Re: **Administrative Amendment – Site Development Plan – Letter of Justification
VCA Vet Care Hospital,
8850 Holly Ave NE, Albuquerque NM 87122**

This memo addresses the review comments received from Marwa Al-najjar on the initial Administrative Amendment Request for the Ventura Place Site Development Plan and associated project at 8850 Holly Ave NE.

Site Plan: Parking Calculations for Administrative Amendment
Scale: 1" = 40'
NORTH

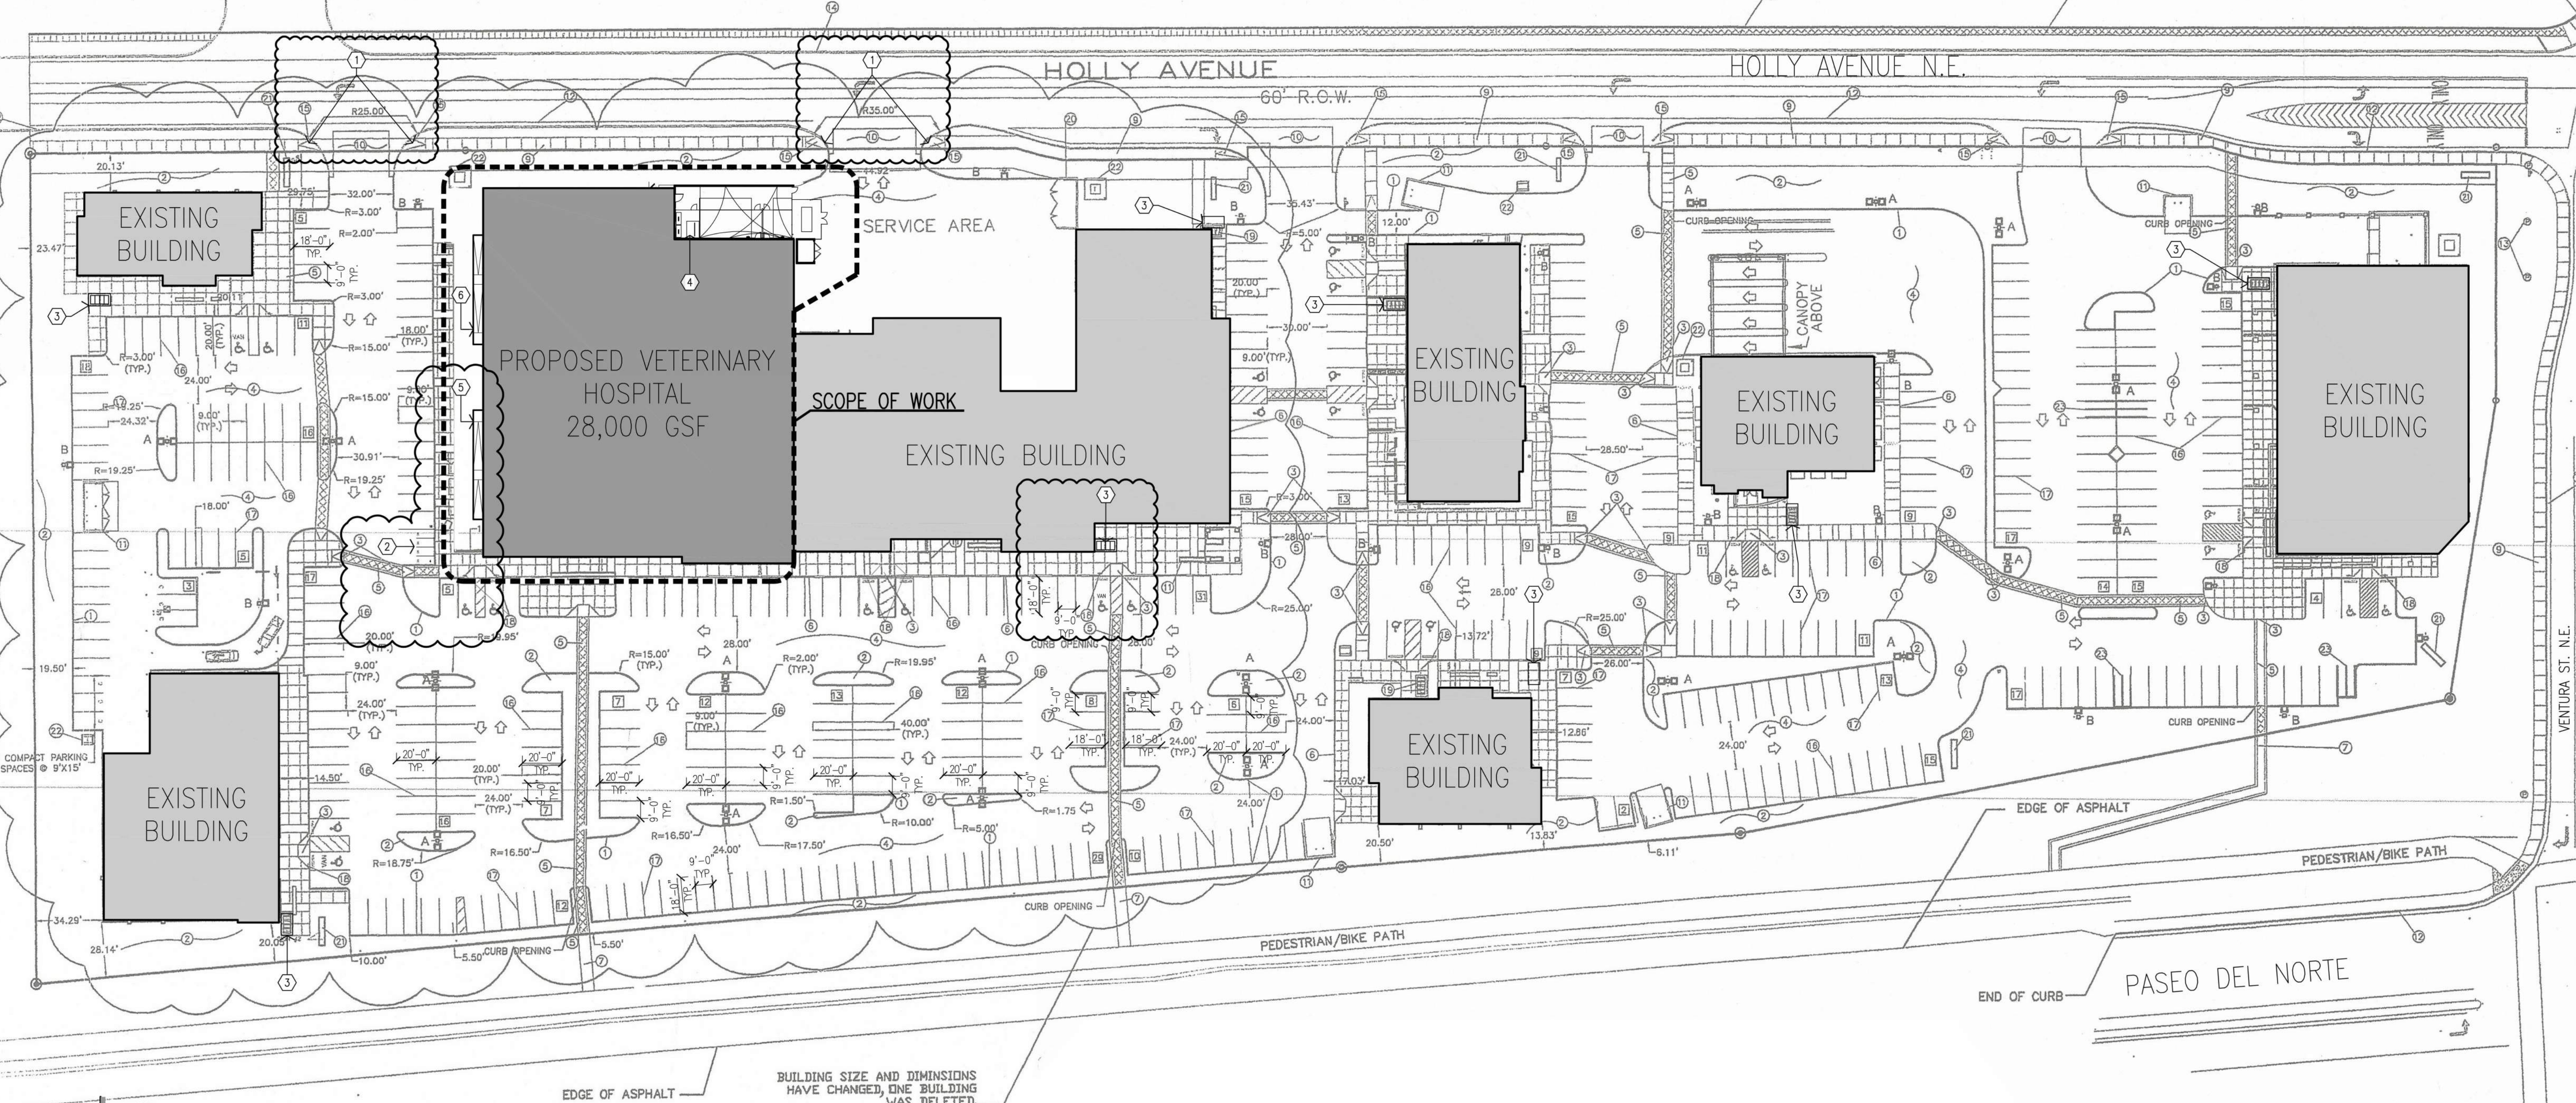
1. List the number of parking spaces required by the IDO for the whole site (parking calculations for each building separately) including the proposed Veterinary Hospital as well as the proposed number of parking spaces including ADA parking, bicycle, and motorcycle parking.
 - *Response: Please find attached a new sheet, A002, with the requested parking calculations. Additionally, please refer to a new diagram, IDO Use Classification Diagram, that shows the existing buildings with areas and use classifications for parking calculations per IDO Table 5-5-1.*

1. 8850 Holly Ave NE - A002 – Site Plan Parking Calculations for A.A
2. 8850 Holly Ave NE - IDO Use Classification Diagram

PARKING CALCULATIONS FOR PROPOSED SITE PLAN

REQUIRED: FOR 501 TO 1,000 PROVIDED SPACES: PROVIDE A MINIMUM OF 10 ACCESSIBLE SPACES
1 IN EVERY 8 SPACES SHALL BE SERVED BY AN ACCESS AISLE
96" WIDE AND SHALL BE DESIGNATED "VAN ACCESSIBLE."
THUS, 8 X 10 SPACES = 1.25 VAN ACCESSIBLE SPACES:
ROUNDED TO 2 VAN ACCESSIBLE SPACES REQUIRED

NON-RESIDENTIAL: 3 SPACES OR 10% OF REQUIRED OFF-STREET PARKING SPACES, WHICHEVER IS GREATER.

REQUIRED BICYCLE PARKING: 10% OF 388 SPACES = 38 SPACES
